MUNCIE POWER PRODUCTS

Product Bulletin #00126

Subject: A20 Series Valve Body Updates

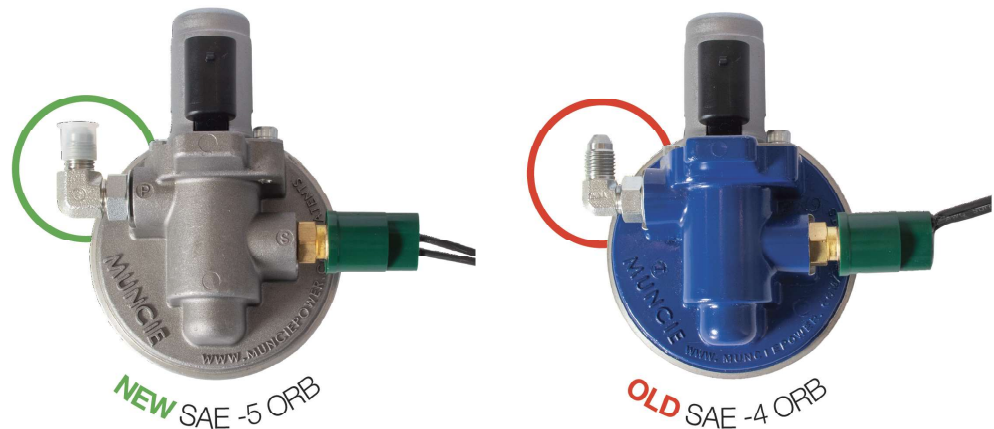
A change is being made to the valve body on the A20 Series power take-off. The new valve body has a -5 ORB port for activation, but will retain the -4 ORB port for the pressure switch. This change is being implemented to prevent plumbing errors, as the -5 elbow will not thread into the -4 switch port, and vice versa. Images of the old and new covers are shown below. Model codes will not be changing. There are no changes to the hose kits.

15T67209 - Standard valve body (shift types HX, H2, JX, J2, XX, RX)

15T67210 - Muncie Start® valve body (shift types SX, S2, RS)

43T64636 - SAE -5 ORB elbow fitting

New valve bodies are backwards compatible with both A20 Series and MC1 Series units, but will require the -5 ORB elbow fitting.
